SEWAGE DISPOSAL SYSTEM

A REPAIR

MARYLAND STATE DEPARTMENT OF HEALTH

SUBDIVISION _____ ROAD 4365 Centennial Lane LOT _____

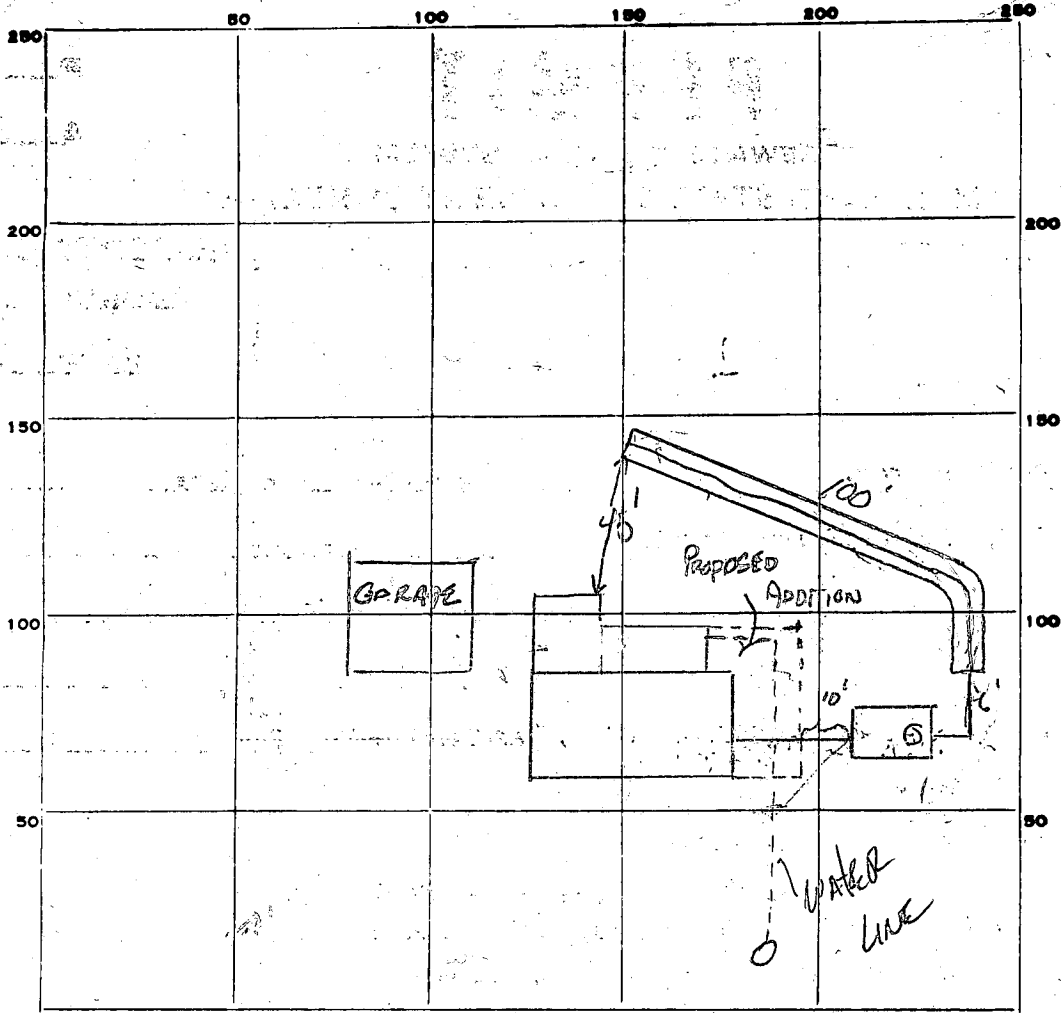
REPAIR - CALL FOR INSPECTION WHEN GROUND IS OPENED UP SO SANITARIAN CAN RECOMMEND REPAIR.

20' x 20' leaching bed 8' deep, 3' stone

35' trench 10' deep 5' stone under pipe. Inlet at 5'

old cesspool to be filled in, water line to be installed in concrete 10' either side of sewer line

PERMIT CARD

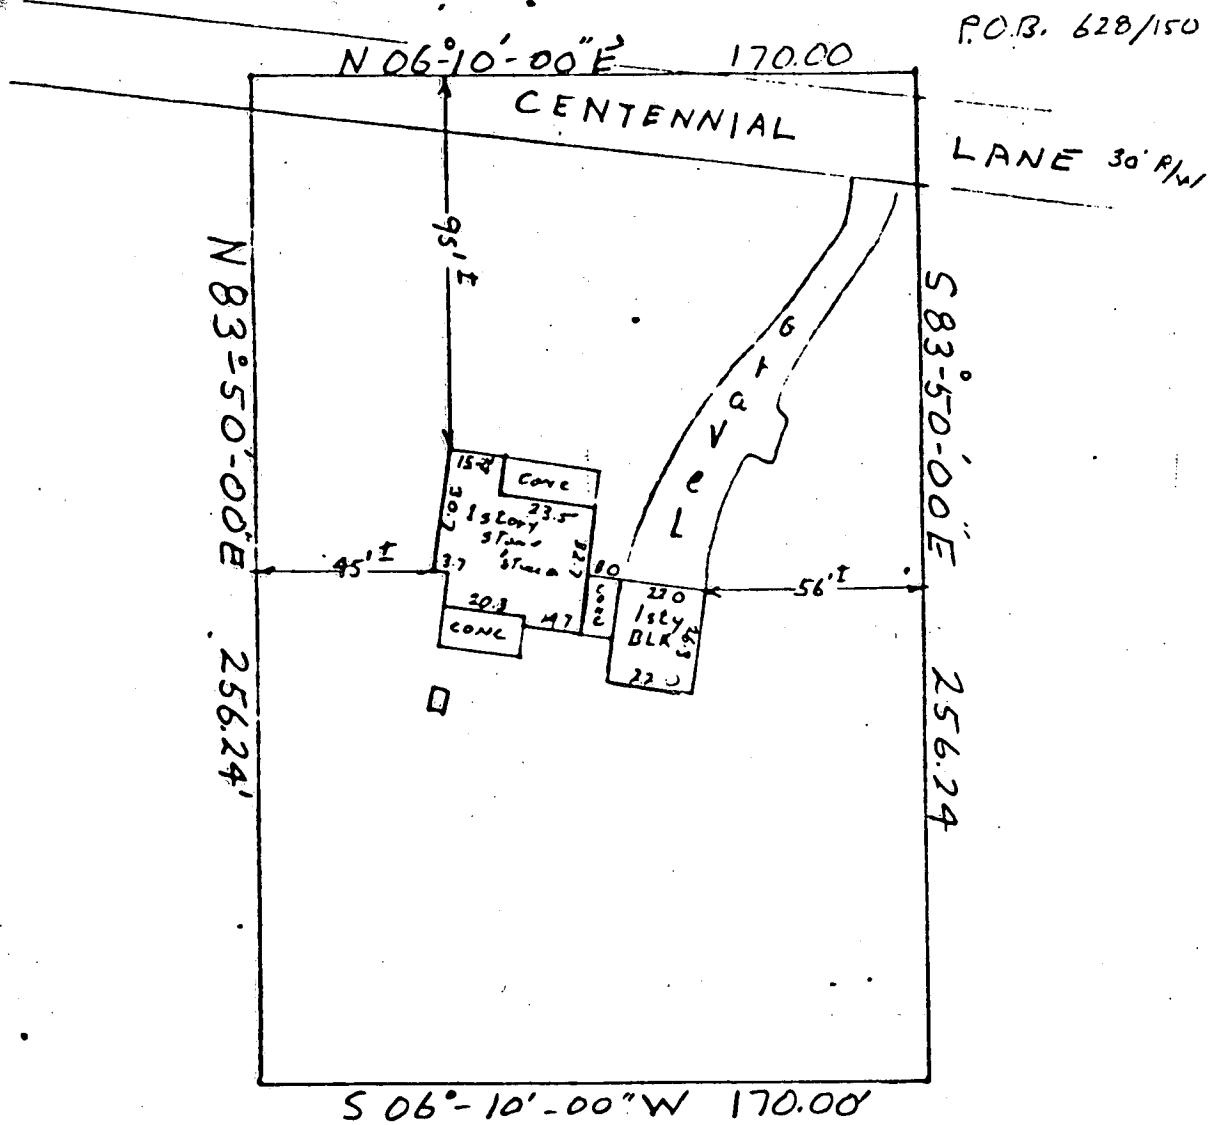
REMARKS 9-18-80 OK TO GRAVEL TRENCH. SK / 9-18-80 OK TO COVER
 all work SK 9-18-80 OR TO COVER all work. need to
 increase public water line for final approval SK /
 9/22/80 - WATER LINE EXCASED IN CONCRETE RH

4365 CENTENNIAL LANE
ELLICOTT CITY
Howard County, Md.
Scale 1" = 50'
L-0910
May, 1994
F-710

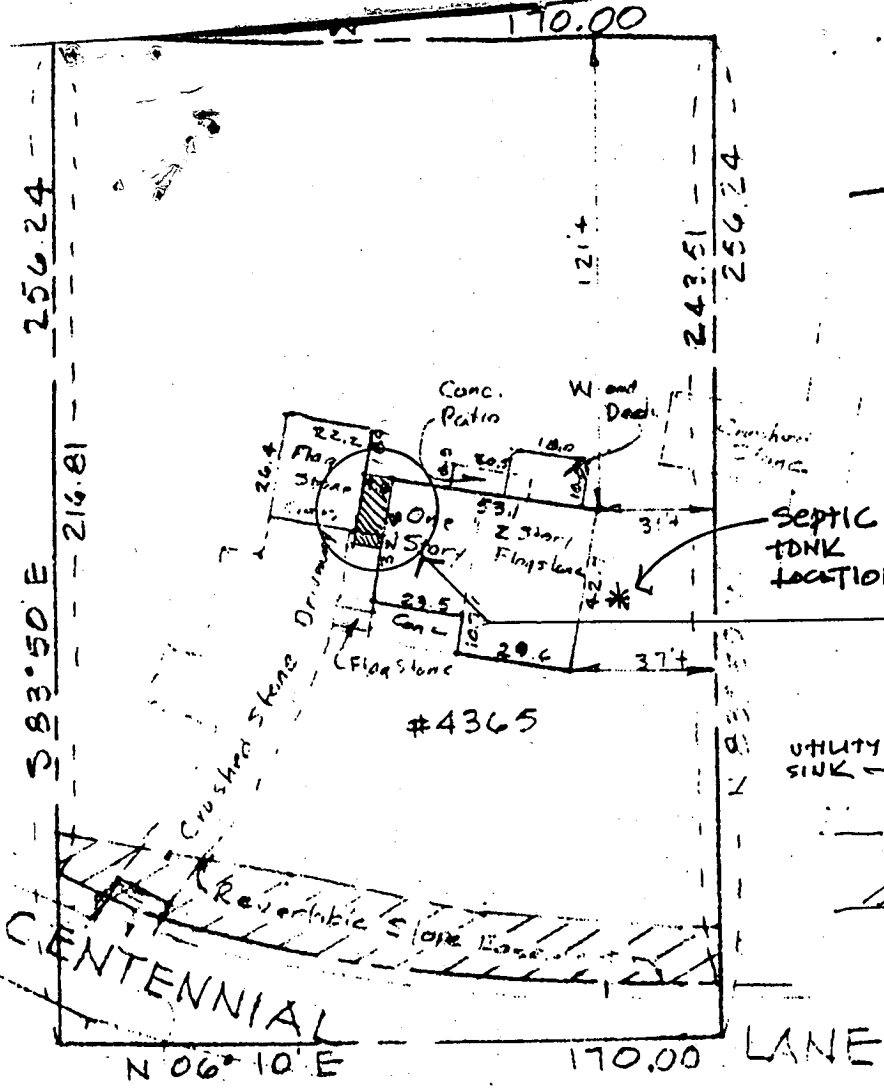
RELOCATION
NO IMPACT TO
EXISTING WALL & SEPTIC
OK TO PROCEED
